This memorandum has been prepared in response to the request for staff memorandum dated January 24, 2012 in the matter of applications for transfer/new water rights No. 73811, 73834, 63-32499, 61-12095, 61-12096, 63-32703, 61-12256, and 63-33344. The following information was requested:

RE: *Response to IDWR Staff Memo regarding the sufficiency of water supply for water right applications and transfers along the I-84 corridor*

January 30, 2013

Figure 4. Water table contour map for October, 2011.

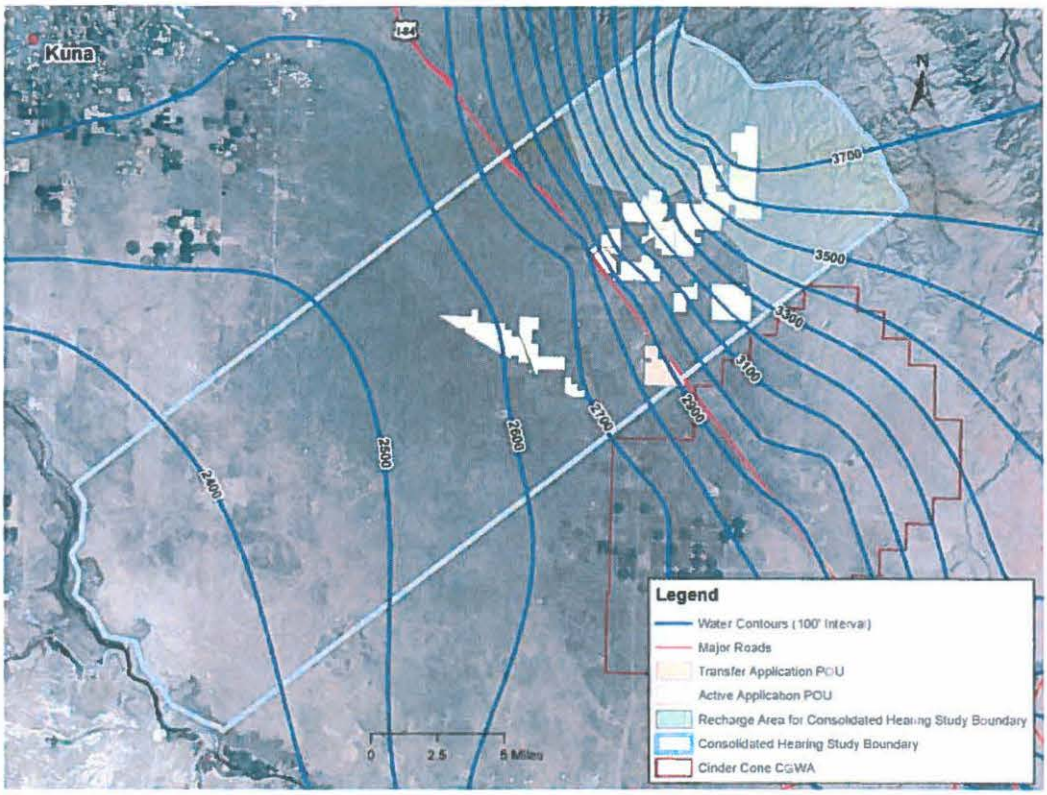
That said, the southwest-northeast study-area boundaries are not entirely perpendicular to IDWR's groundwater-level contours (see Figure 4 of the IDWR Staff Memo) in the southern portion of the study area. As such, the study boundaries appear to not be aligned along regional flow lines in this area. However, Lindholm et al. (1988) defined regional groundwater-level contours using a much larger (and more regional) data set. Figure 1 shows (a) Lindholm et al.'s groundwater-level contours, (b) IDWR groundwater-level contours presented in Figure 4 of the IDWR Staff Memo, and (c) IDWR water-level contours that SPF reinterpreted based on the previous Lindholm et al. contours. Inferred groundwater flow lines based on the IDWR contours and Lindholm et al. regional groundwater-level contours represent a reasonable basis for IDWR's southwest-northeast study-area boundaries.

Figure 5. Groundwater level change maps for the Cinder Cone CGWA for the fall season between the years (a) 1981 and 1991, (b) 1991 and 2001, (c) 2001 and 2011, and (d) 1981 and 2011.

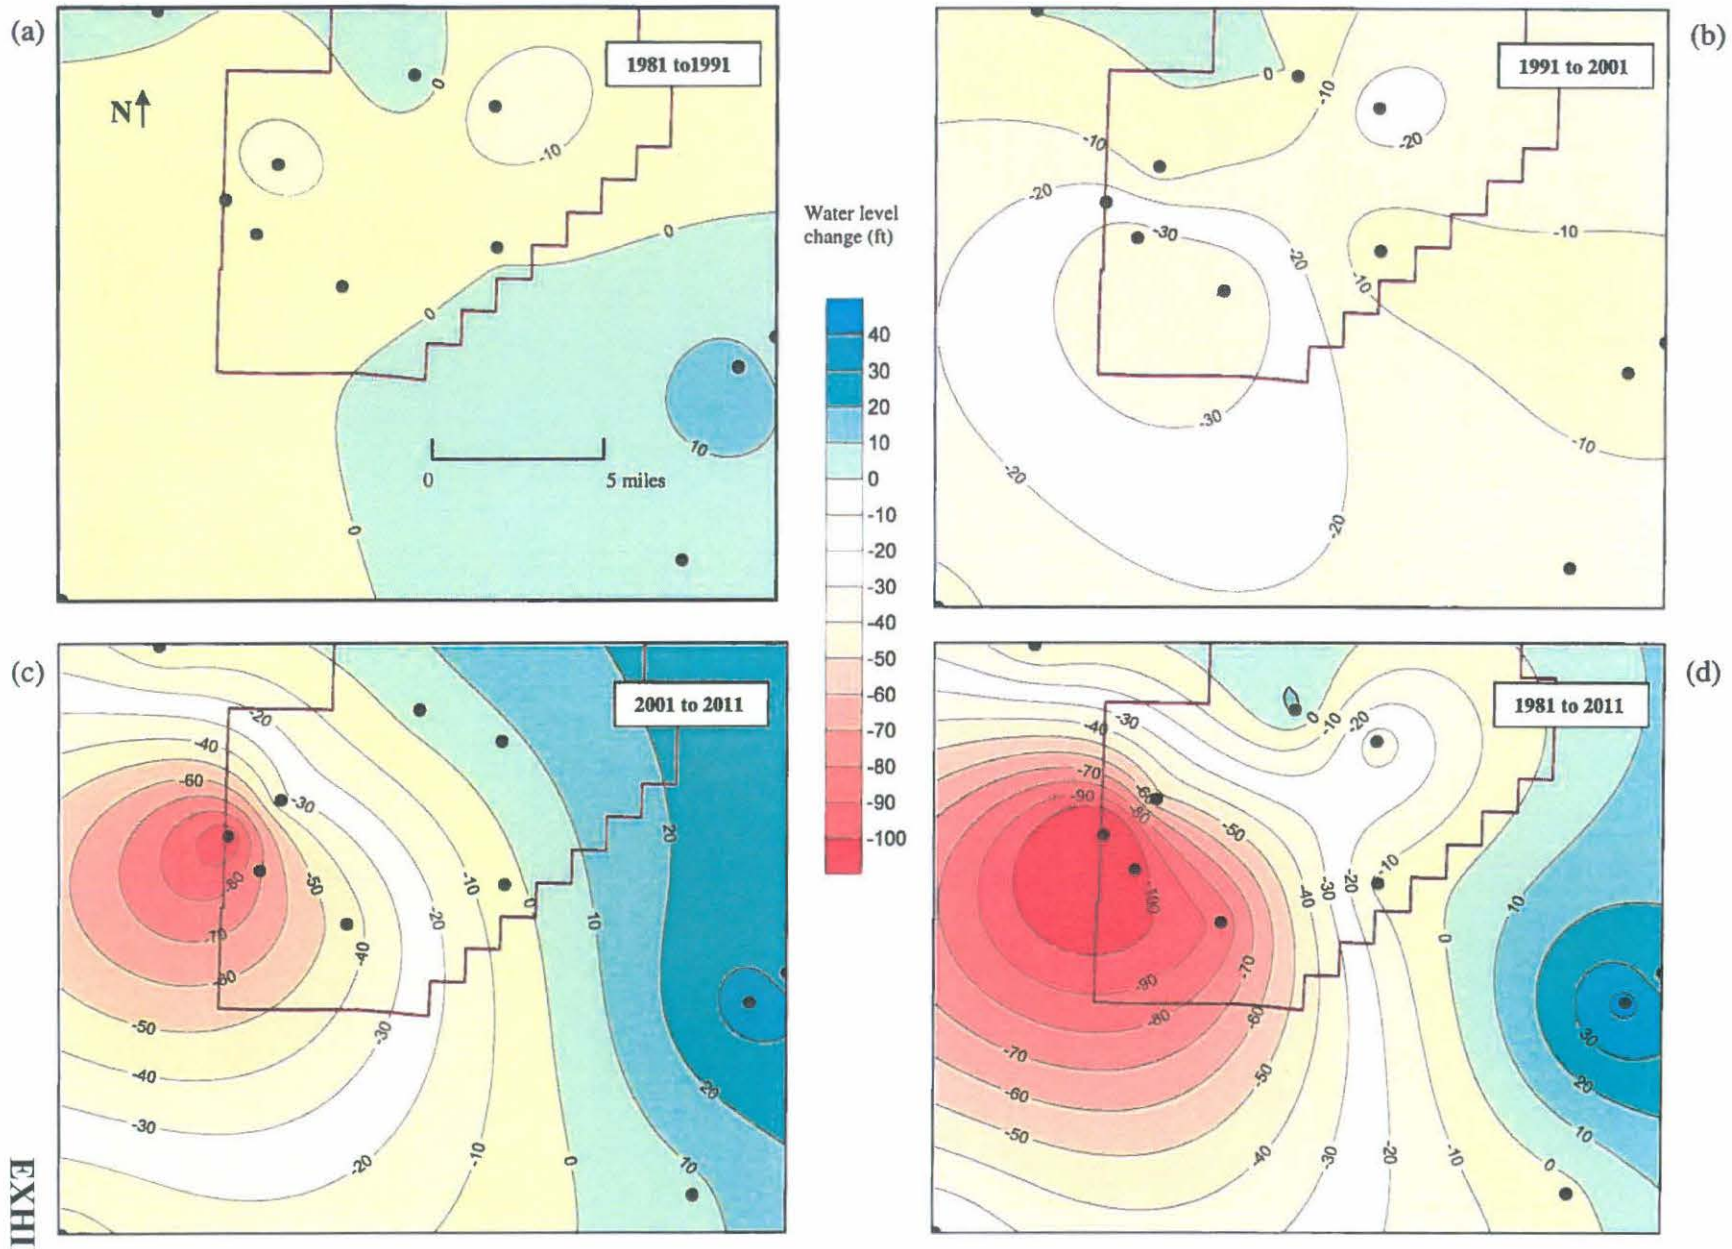
4. There clearly have been groundwater-level declines within the Cinder Cone Butte CGWA, but the degree to which water level declines within the CGWA have extended outside of the CGWA is unclear. Groundwater-level contours shown Figure 5 of the IDWR Staff Memo[8] show substantial declines extending west and southwest (i.e., outside) of the CGWA in the consolidated cases study area, but these depictions of the study-area groundwater-level declines represent a software interpolation unsupported by actual groundwater-level data.

3. ERO uses Figure 5 of the IDWR Staff Memo to suggest that a 20-mile diameter area of groundwater-level decline stemming from pumping in the Cinder Cone Butte Critical Ground Water Area (CGWA) extends substantially into the consolidated cases study area. However, the IDWR depictions of groundwater-level declines outside of the CGWA are based on software interpolation unsupported by actual groundwater-level data.

3. *ERO argues that "The diameter of the water level decline attributed to pumping in the CCBCGWA is approaching 20 miles" based on Figure 5 in the IDWR Staff Memo (ERO review, page 15), implying that pumping from the Cinder Cone Butte CGWA has materially impacted groundwater levels in the study area, rendering the boundary separating the study area and the comparison area invalid.*

ERO's argument appears to be based on a map of purported groundwater-level declines stemming from Cinder Cone Butte CGWA pumping (see Figure 5, IDWR Staff Memo). However, the IDWR depictions of groundwater-level declines outside of the CGWA are based on software interpolation unsupported by actual groundwater-level data. Furthermore, Figure 4 of the IDWR Staff Memo also does not appear to indicate groundwater-level declines within the study area stemming from Cinder Cone Butte CGWA pumping. Thus, neither Figures 4 nor 5 of the IDWR Staff Memo support the concept of a 20-mile diameter water-level decline attributable to pumping in the Cinder Cone Butte CGWA.

Perhaps more telling is that approximately 40 years of pumping in the Cinder Cone Butte area has not resulted in the type of water-level decline projected by ERO's Theis results. IDWR Figure 5(d) suggests that there has been zero water-level decline since 1981 in the vicinity of the proposed applications and transfers as a result of Cinder Cone Butte area pumping over the past several decades. Thus, although ERO's Theis analysis might predict widespread water-level decline within the study area as a result of proposed pumping, monitoring data from actual pumping in the Cinder Cone Butte area demonstrate otherwise.

Figure 1. Cinder Cone CGWA Well Hydrographs

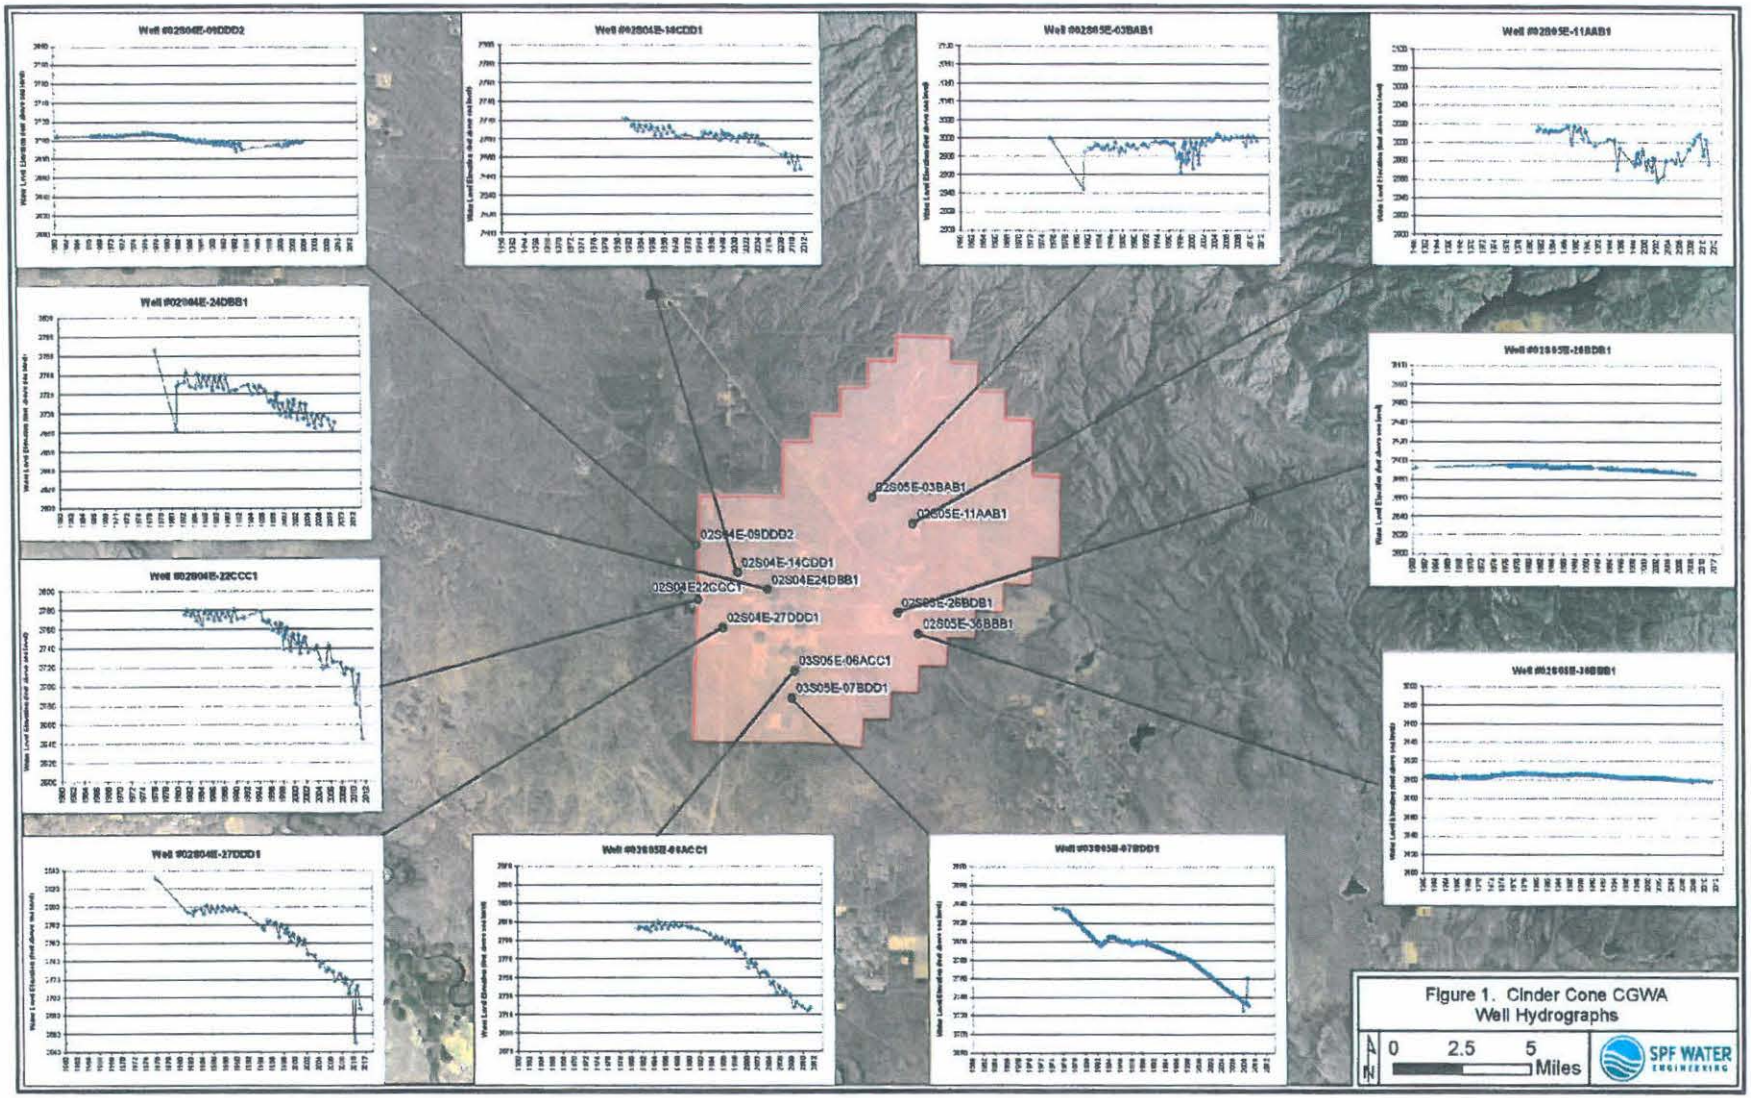
5. Hydrographs[9] in the southwestern portion of the Cinder Cone Butte CGWA show a consistent downward trend in groundwater levels. It appears that drillers' reports are available for only 6 of the 11 wells used in this analysis[10]. Some of the wells for which drillers' reports are available have very broad completion intervals (e.g., Well 02S05E-06ACC1 has an open interval of over 1,000 feet). It is not clear whether the observed water-level declines represent aquifer conditions throughout these open intervals or in individual aquifer zones.

plotted with consistent y-scales the hydrographs show that the area of greatest declines is limited to the southern portion of the CGWA (Figure 1, page 15).

Figure 1. Inferred groundwater flow directions at study-area boundaries.

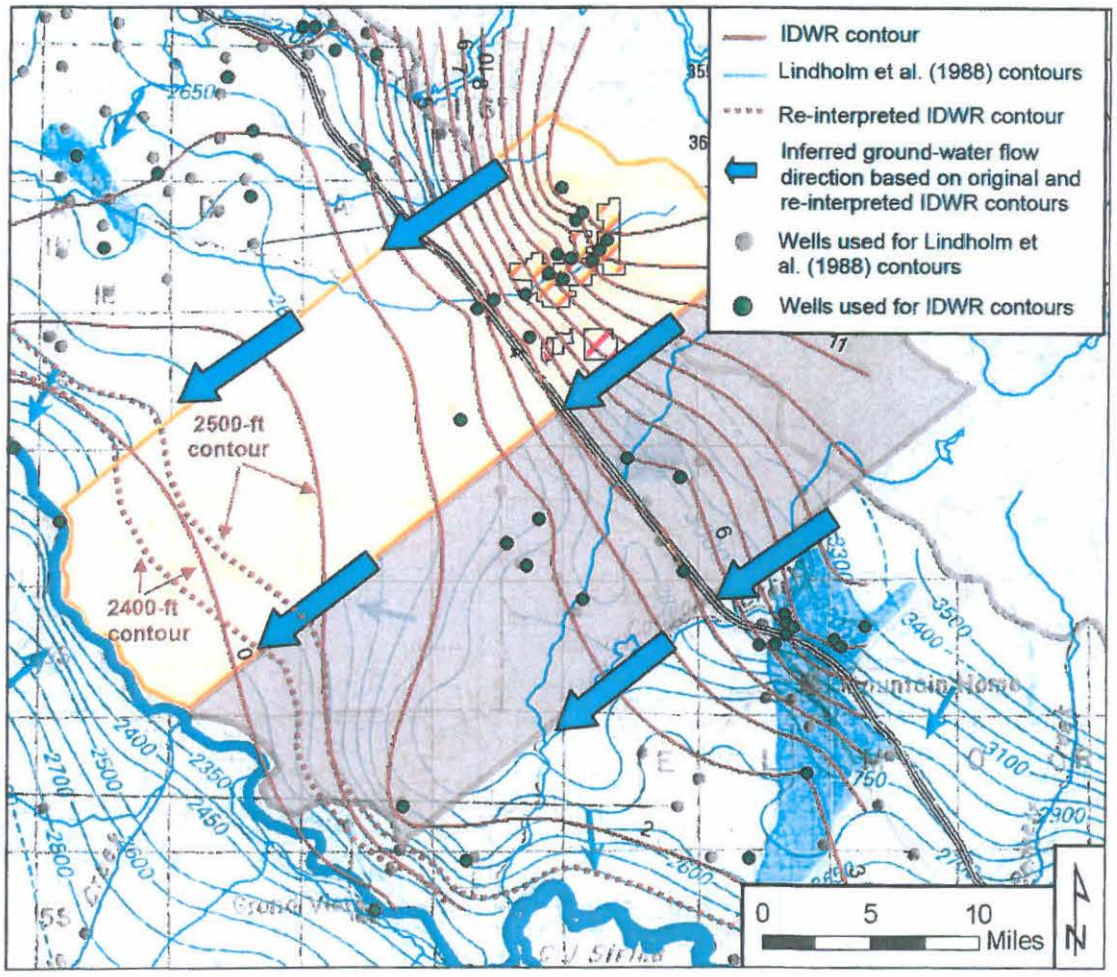
Response. The study area designated by IDWR for evaluating groundwater supply is appropriately sized and technically defensible. The study area encompasses all of the proposed points of diversion and proposed places of use. The study area is defined by defensible boundaries.

Figure 3. Locations of wells in the upper Blacks Creek drainage with groundwater-level data.

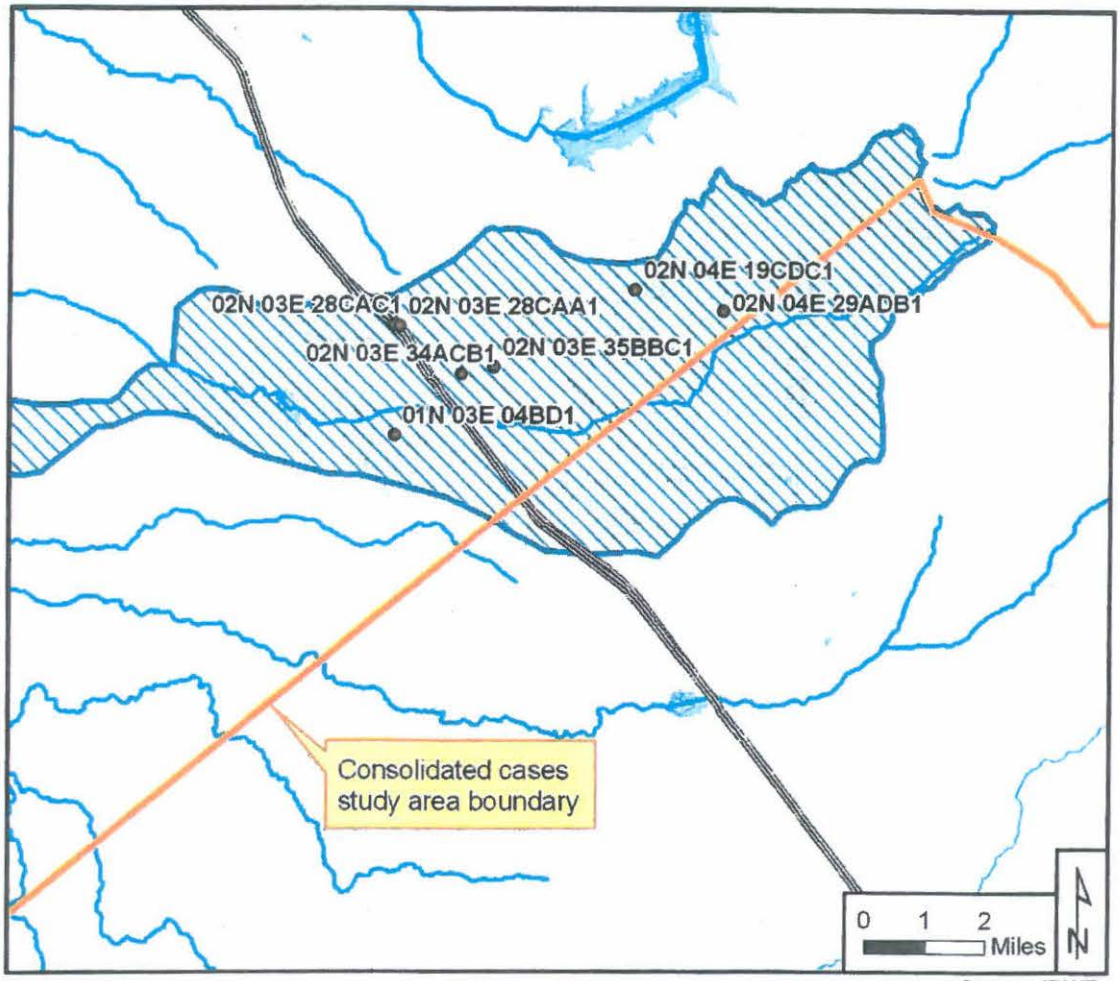
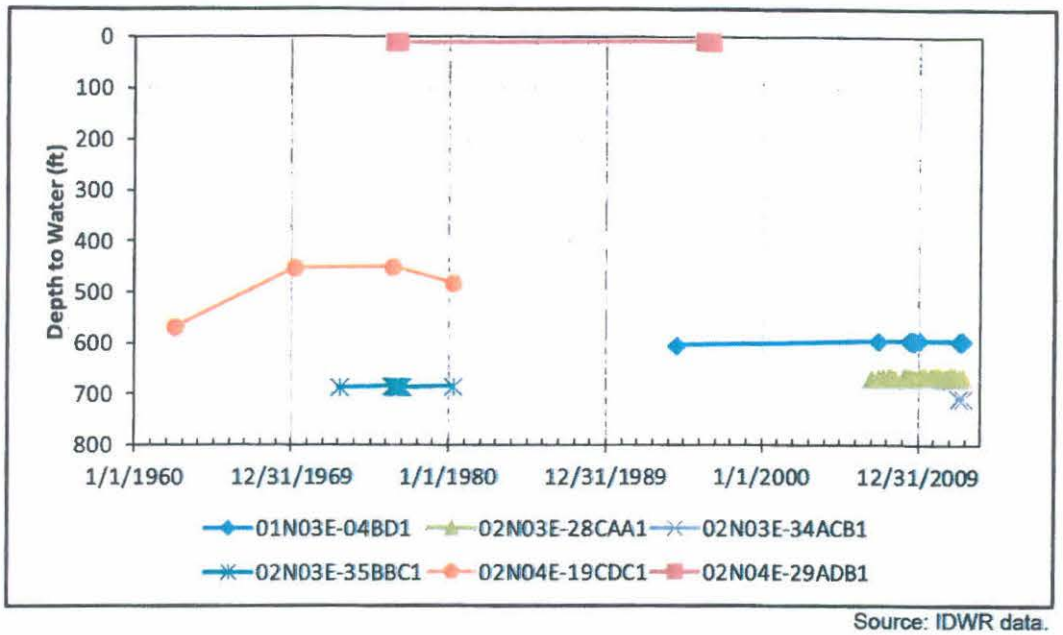
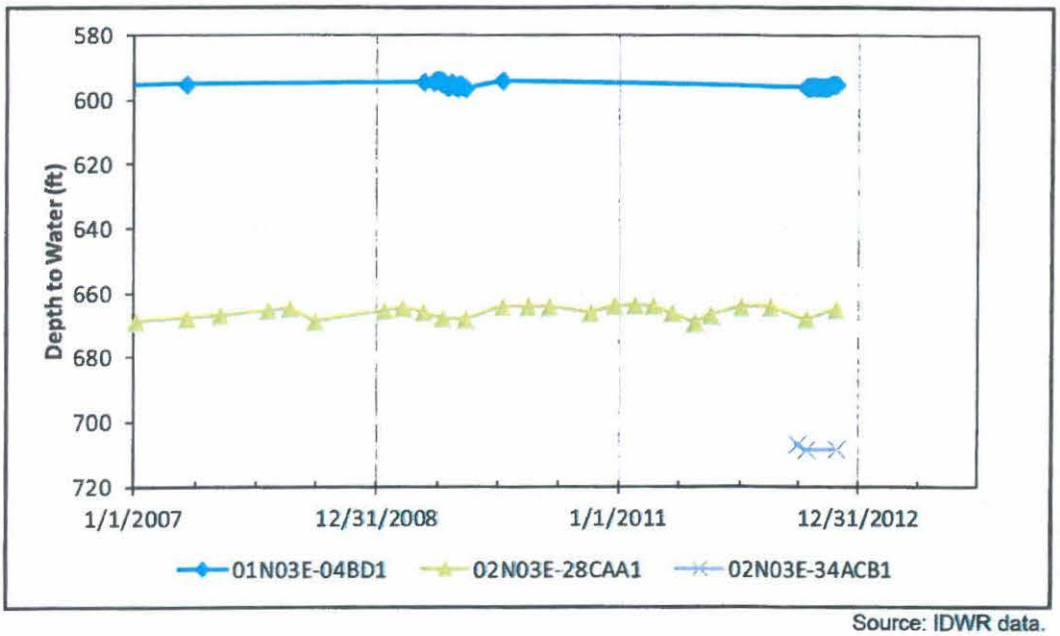
Locations of wells in the upper Blacks Creek drainage with publicly-available groundwater-level data are shown in Figure 3. Hydrographs from these wells (Figure 4 and Figure 5), including a well within ¼-mile from the point of diversion for water right 63-11540, show no groundwater-level declines, indicating that diversions authorized under water right 63-11540 have not created (and therefore likely will not create) groundwater-level declines in the upper Blacks Creek drainage area. Thus, it appears that ERO's concerns about long-term effects of pumping outside this portion of the study area are unfounded.

Figure 8. Portion of "non-recharge area" from which recharge capture is likely.

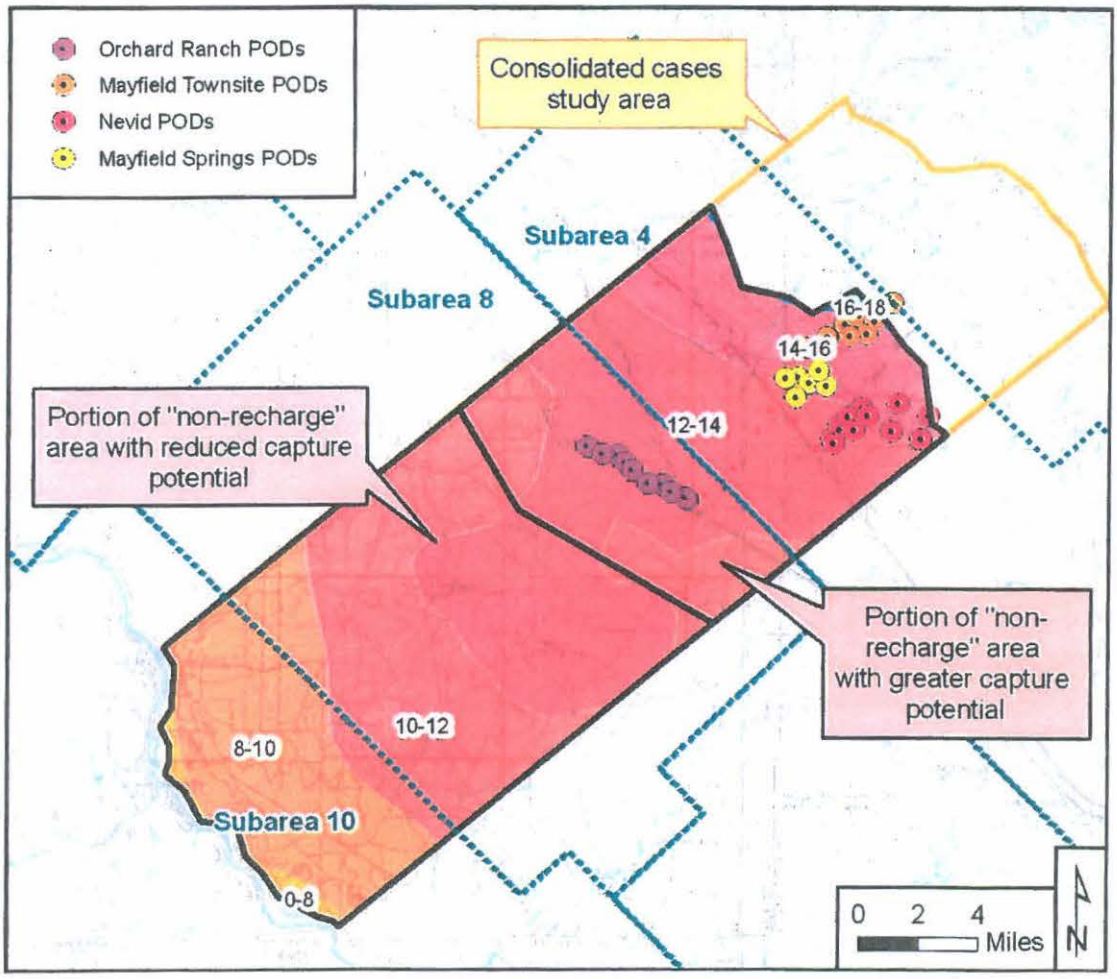
Figure 8 illustrates a portion of the "non-recharge" area with greater potential of capturing recharge originating from the "non-recharge" area and an area with reduced capture potential. The line separating these two portions of the "non-recharge" area is approximately 3 miles down-gradient of the Orchard Ranch wells, which presumably could develop an approximate 3-mile capture radius.

The amount of average annual recharge generated within the portion of the "non-recharge" area having greater capture potential was estimated using the same estimated USGS recharge percentages (Newton, 1991) and PRISM data that IDWR used in developing a recharge estimate for the "non-recharge" area. Using this approach, the amount of recharge within the portion of the "non-recharge" area having greater capture potential is approximately 1,950 acre-feet per year (Table 1).
